## APPLICATION FOR A CERTIFICATE OF APPROPRIATENESS – STAFF REPORT

022-18-CA      606 E LANE STREET

Nature of Project: Construct 2-story rear addition; construct dormer on west side; insert new windows on east and west sides; replace rear patios and walkways; alter driveway

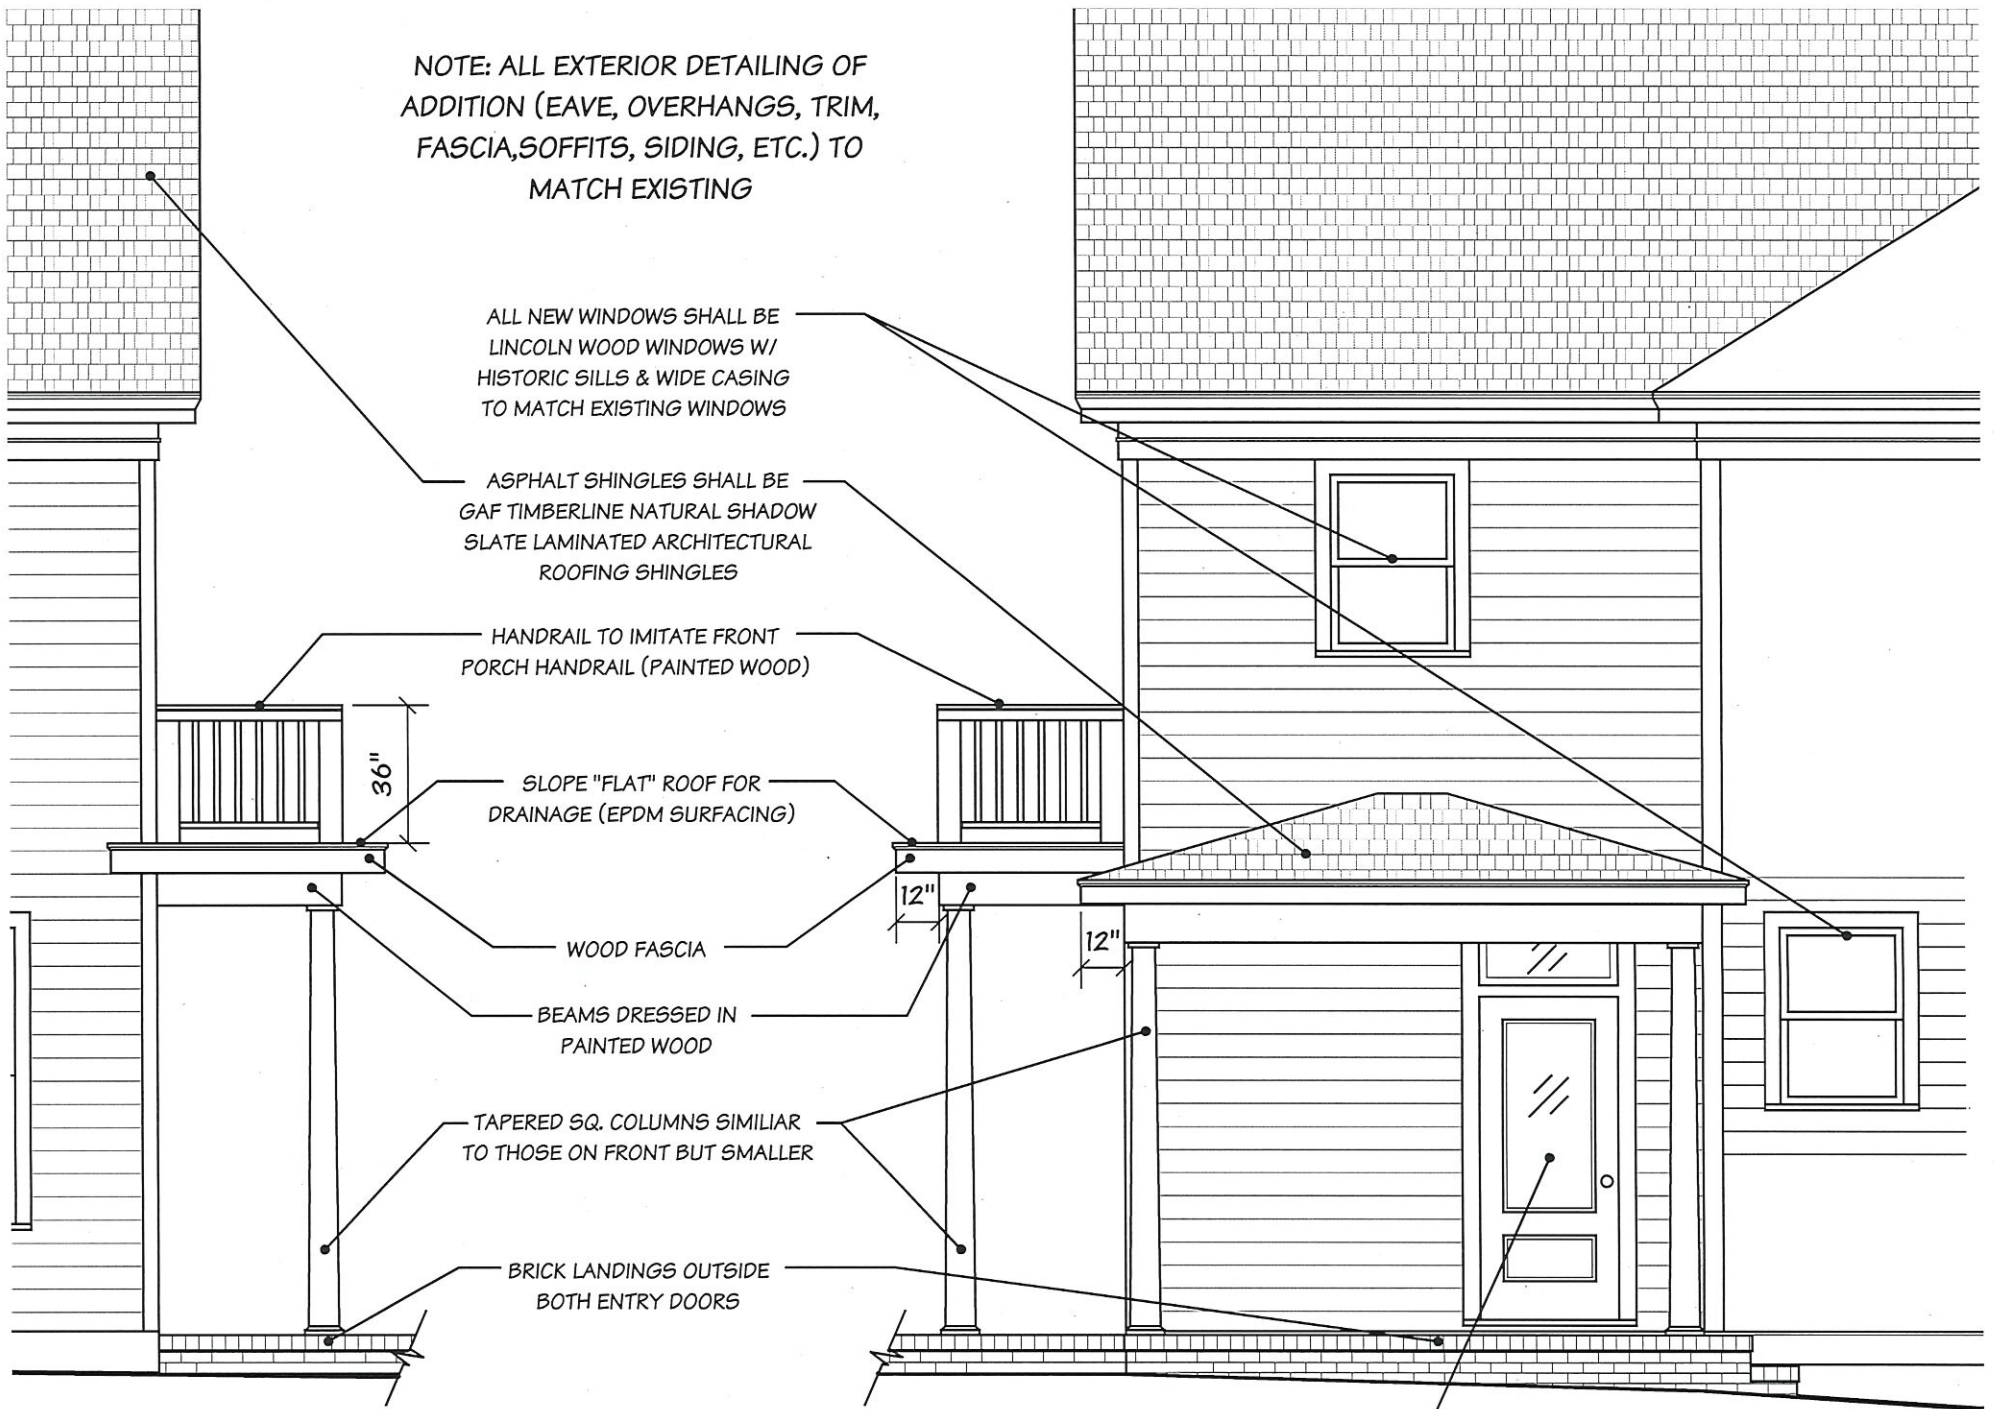
- 4\* The proposed cladding is fiber cement, matching the existing profile of the weatherboard. The application did not state if it would be installed with the smooth face out. Because of the inset the fiber cement siding and wood siding will not meet on the same plane.

- 5\* The drawings show that the eave, overhangs, trim, fascia, and soffits will match the existing materials.
- 6\* The proposed windows are wood windows to match the existing. Window specifications were not provided. Window trim is proposed to match the existing. Neither detailed drawings nor close-up photos of the existing trim were provided.

- 7\* Doors are proposed to be  $\frac{3}{4}$  light with a lower panel and transom above. Door specifications were not provided.
- 8\* The roof is proposed to be a gable form. Roofing is proposed to be asphalt architectural roofing shingles.

- 9\* The side porch is proposed to include a hipped roof supported by squared wood columns that reflect the design of those on the front porch.
- 10\* The rear porch includes a small balcony above it, again supported by squared columns. According to drawings, the handrail for the balcony is "to imitate front porch handrail (painted wood)." A section drawing for the railing was not provided.

- 11\* One of the drawings shows brick landings at the new side and back doors, as well as a brick foundation. A brick sample was not provided.
- 12\* It is unclear from the application if any trees will be impacted during construction or as a result of the addition or backyard alterations. A tree protection plan was not provided.

- 1. That the fiber cement siding be installed with the smooth face out.
- 2. That tree protection plans be implemented and remain in place for the duration of construction.

- 3. That specifications and details for the following be provided to and approved by staff prior to the issuance of the blue placard:
  - a. manufacturers specifications for new windows, including elevation and section drawings;

- b. window trim;
  - c. eave detail drawing;
  - d. tree protection plan prepared by an arborist certified by the International Society of Arboriculture or a Licensed Landscape Architect that addresses the critical root zones and provides staging areas for construction materials;

- e. dormer details.
- 4. That specifications and details for the following be provided to and approved by staff prior to installation/construction:
  - a. manufacturers' specifications for new doors, including elevation and section drawings;

- b. section drawing for rear porch railing;
  - c. brick sample;
  - d. paint schedule and samples from paint manufacturer;

## SP2.1 | PROPOSED SITE PLAN

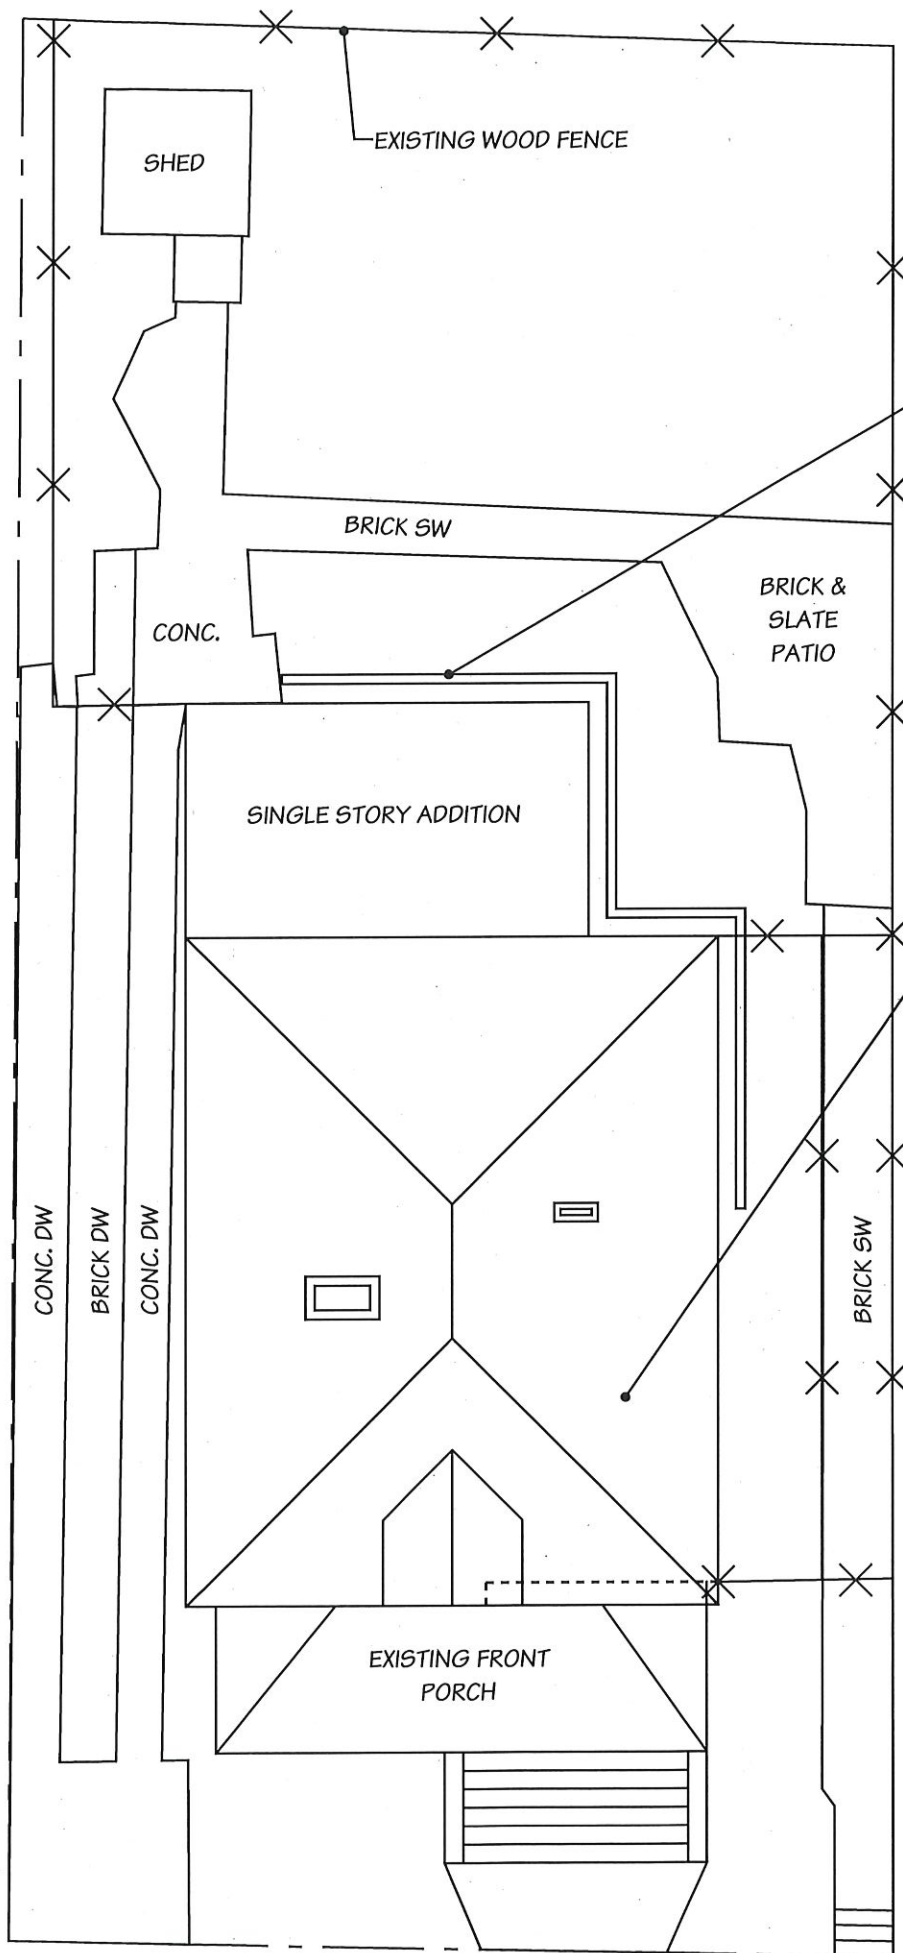
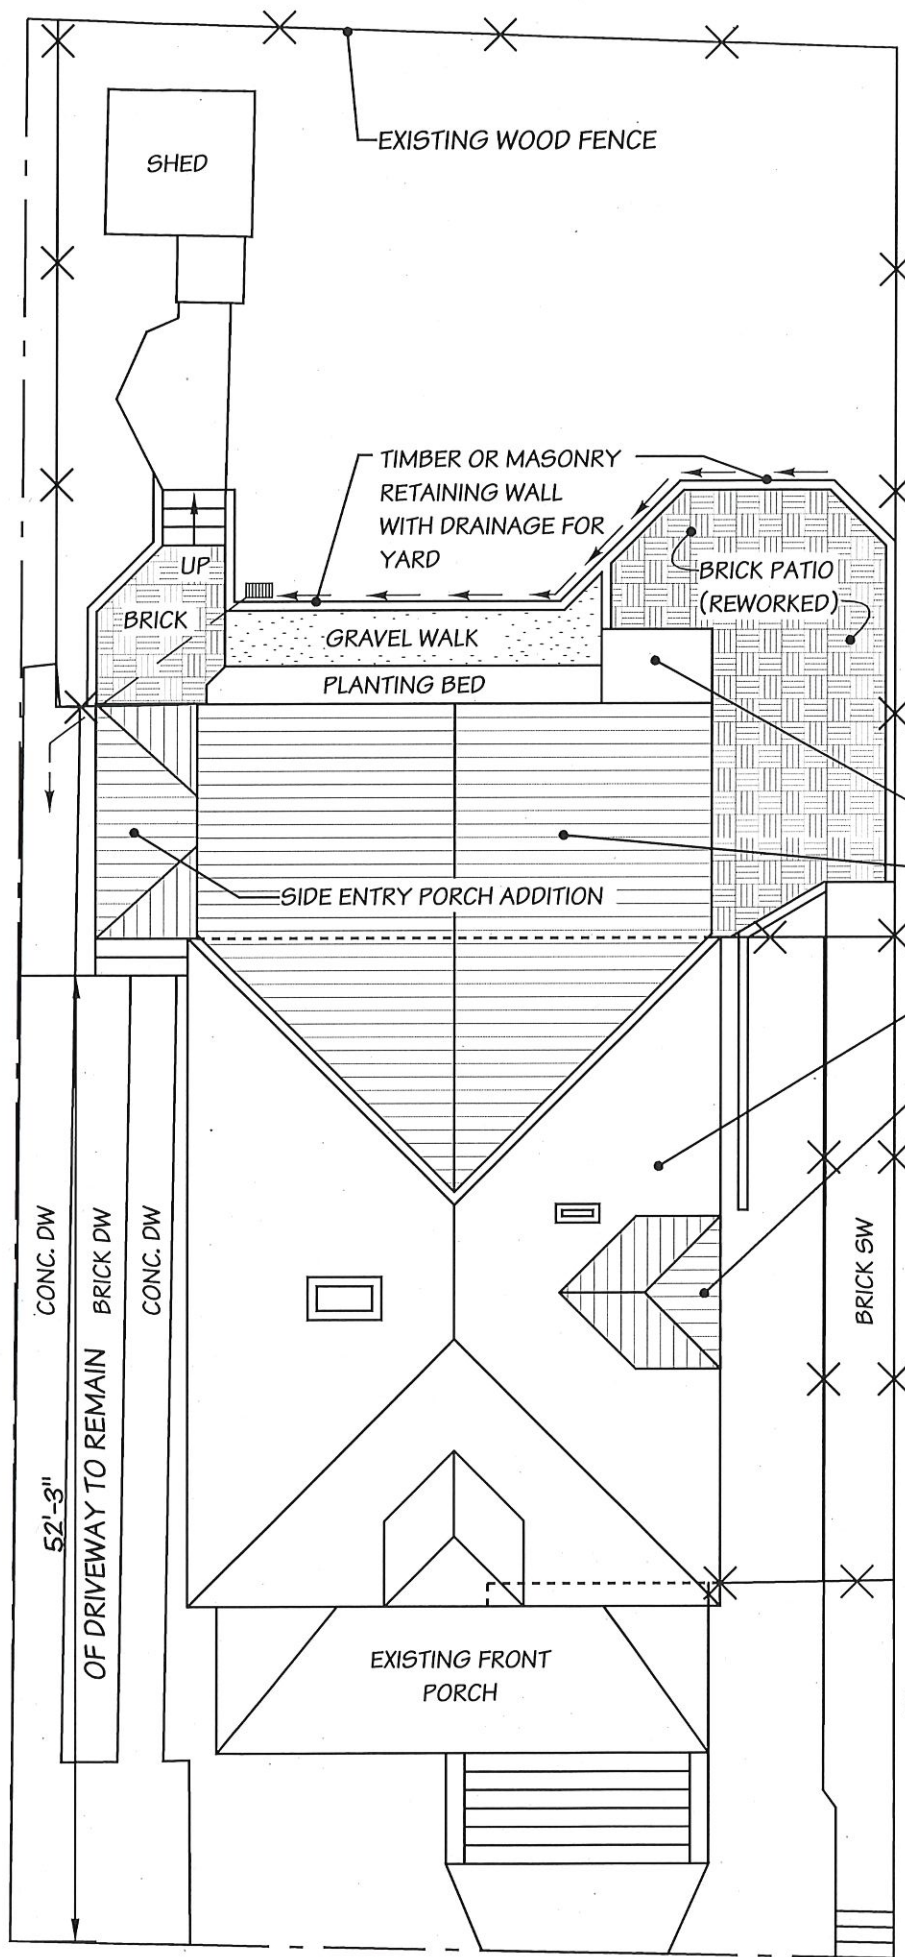
1\* A brick and slate patio, brick walkway and concrete patio are proposed to be replaced with brick patios and a gravel walk. Samples of the brick pavers and gravel were not provided.

2\* The application states that the driveway will be shortened approximately 12' due to the addition of the side porch. The driveway is a concrete ribbon design with brick infill and concrete curbs flanking both sides.

- 3\* It is unclear from the application if any trees will be impacted during construction or as a result of the addition or backyard alterations. A tree protection plan was not provided.
- 4\* Photographs of the rear yard were not provided.
- 5\* A shallow retaining wall that does not appear to be historic is proposed to be removed from the rear of the house. A new retaining wall constructed of timber or masonry will be moved to a new location south of the proposed gravel walkway. Timber retaining walls are atypical in the historic district.

- e. exterior lighting, gutters and downspouts, including locations on the elevations;
- f. brick paver and gravel samples;
- g. masonry sample for backyard retaining wall.
